Access Compliance Report

Public Rights-of-Way

Intersection ID: 52926	Main Street: WALTHAM_LN	Cross Street: EMORY_OAK_DR	Location: E
ADA ID: 282DC42B35B2	Ramp Type: Perp	Initial Pass/Fail: Fail	Overall Compliance: No
Severity Score: 8.75			
Codes/Mitigation Info/Possible Solution		Field Measurements/Component Compliance

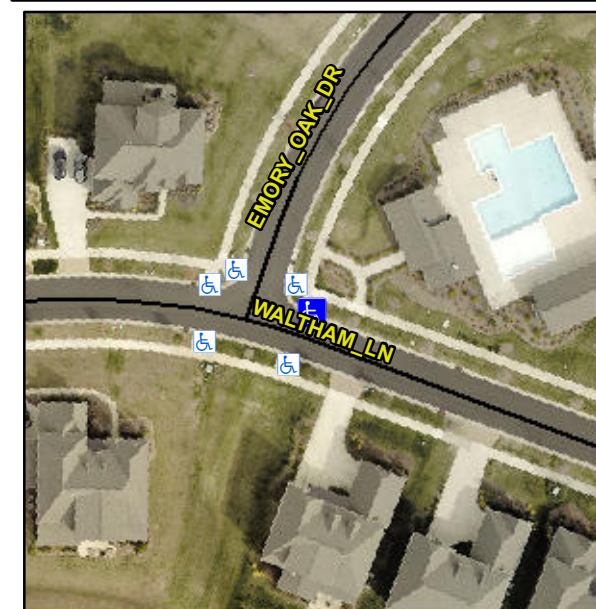
Not Found, R304.5.1

Compliance	Description	Data	Compliance	Description	Data
N/A	Ramp Length (in)	95.5	Yes	Ramp Slope (%)	5.0
No	Ramp Width (in)	44.5	Yes	Ramp XSlope (%)	1.0
N/A	Flare Type LT	N/A	N/A	Flare Type RT	N/A
N/A	Flare Slope LT (%)	N/A	N/A	Flare Slope RT (%)	N/A
N/A	Flare Traversable LT?	N/A	N/A	Flare Traversable RT?	N/A
N/A	Landing Length (in)	N/A	N/A	DWS Provided?	N/A
N/A	Landing Width (in)	N/A	N/A	DWS Contrast?	N/A
N/A	Landing Slope (%)	N/A	N/A	DWS Length (in)	N/A
N/A	Landing X Slope (%)	N/A	N/A	DWS Full Width?	N/A
N/A	Landing Curb? (Y/N)	N/A	N/A	DWS Offset (in)	N/A
N/A	Shared Landing?	N/A			
N/A	Gutter Ponding?	N/A	N/A	Gutter Slope (%)	N/A
N/A	Gutter Lip Ht (in)	N/A	N/A	Gutter X Slope (%)	N/A
N/A	Painted X Walk1?	No	N/A	Painted X Walk2?	N/A
	X Walk 1 Direction	To S		X Walk 2 Direction	N/A
N/A	X Walk 1 Width (in)	N/A	N/A	X Walk 2 Width (in)	N/A
	X Walk 1 Slope (%)	2.9		X Walk 2 Slope (%)	N/A
	X Walk 1 X Slope (%)	1.1		X Walk 2 X Slope (%)	N/A

Remove & Replace Entire Ramp.
